**DESIGN/DEVELOPMENT REVIEW COMMISSION  
DESIGN REVIEW DISTRICT  
EVALUATION SHEET  
Case #2**

**ADDRESS:** CanalSide, bordered by Hampton, Williams, Blanding Street, and the City Esplanade

**NATURE OF REQUEST:** Request for Certificate of Design Approval for new construction of two buildings and associated parking

**North Elevation**

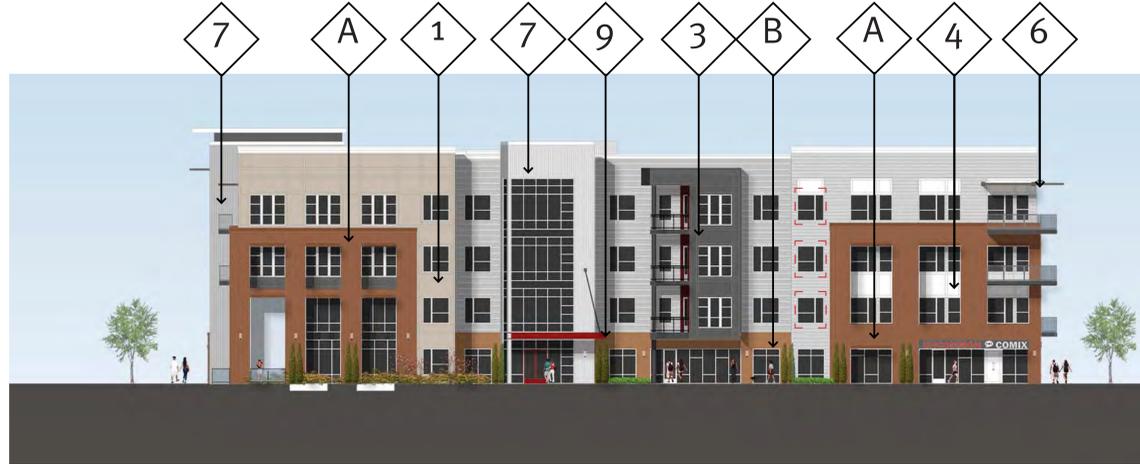
The percentage of glazing on Building II has been provided for the North and East elevations. The north elevation is close to the recommended lower/upper percentages, at 63/38 respectively. The East (Taylor Street) elevation has 74/42 respectively. Percentages for the South elevation are 54/36, respectively.

The upper story fenestration calculations (north and east elevations) range from 38-42%, near the recommended 40%.

**East Elevation**

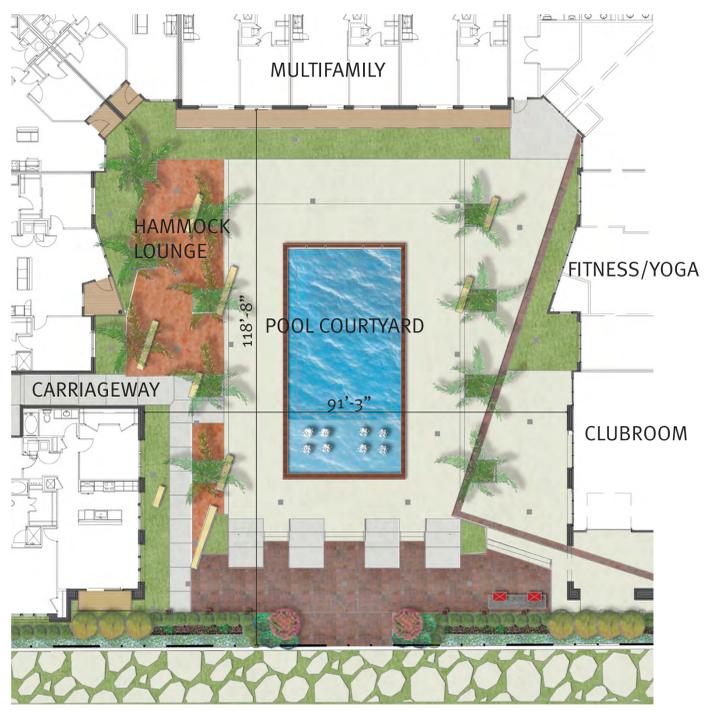
The lobby on the east elevation is signified by a large glass curtain wall and a canopy over the door. The other entrances are not particularly emphasized except for signage over retail spaces.

There is a canopy on the glass tower element, helping to draw attention to the lobby entrance.

**03** Detail - Recessed Window Head (@ Siding)  
Scale: 3"=1'-0"

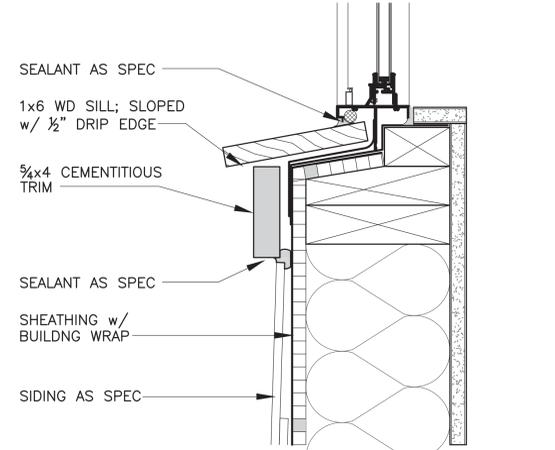
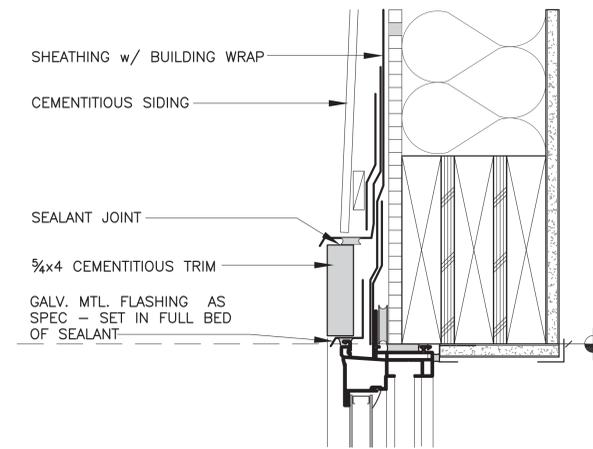
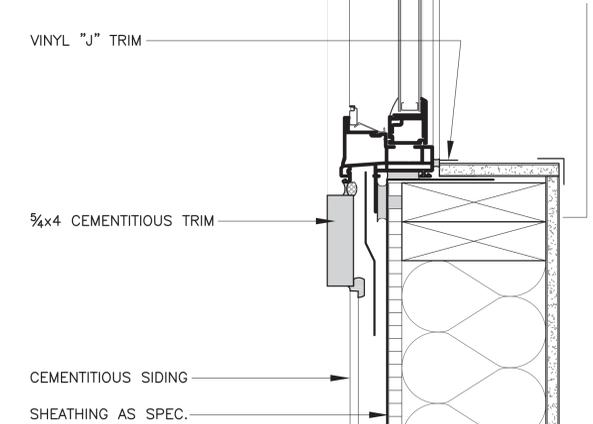
Windows sections have been provided; the applicant has added details to indicate recessed windows in some select locations on the cementitious-panel facades. This will greatly improve the articulation of the facades; providing more information about where the recessed windows occur would be helpful.

- Rooftop mounted utility equipment must be screened; screening shall be reviewed and approved by staff.
- Recessed windows within cementitious panel exterior walls shall be identified on the facades; at least 50% of these windows on street-facing elevations be recessed.
- All other details to be deferred to staff.
